UNITED STATES PATENT AND TRADEMARK OFFICE

10/552,097

Claim Rejections - 35 USC § 102

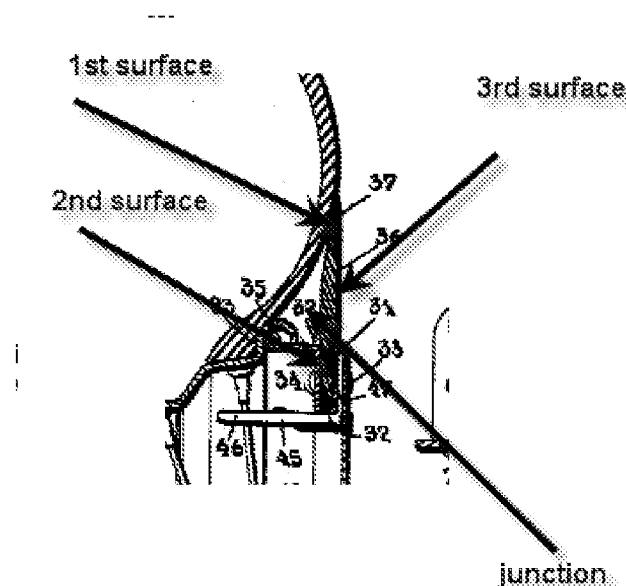
Roth discloses it is known to have a separate part on both sides of the wheel with a first surface in contact with the tire (see figure below), the second surface in contact with the rim (17,23,35,32,34) and third surface extending across the gap on an aircraft wheel (see figure below) wherein the separate part is flexible and made of rubber (col 2, line 21) thus deformable and capable to be moved manually.

Regarding claim 33, Large, as modified, discloses the apparatus as in claim 15 wherein the first surface follows the shape of the tire (see figure above).

Regarding claim 34, as best understood, Large, as modified, discloses the apparatus as in claim 15 wherein the first surface follows the shape of the rim (see figure above).
